PRODUCT CHANGE NOTICE

PCN #18-152

CSBP-A1843+

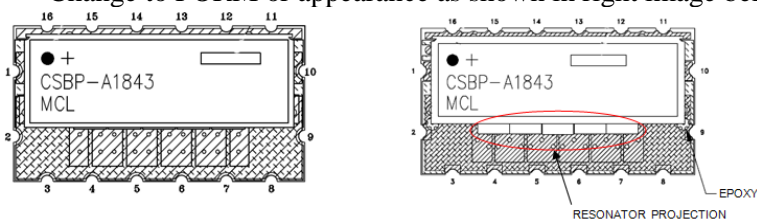
Redesign of internal circuit to reduce variation resulting from supplied capacitor lots, by replacing single capacitor with 2 series capacitor.

- No change to FIT or FUNCTION, performance repeats with greater consistency
- Change to FORM or appearance as shown in right image below:
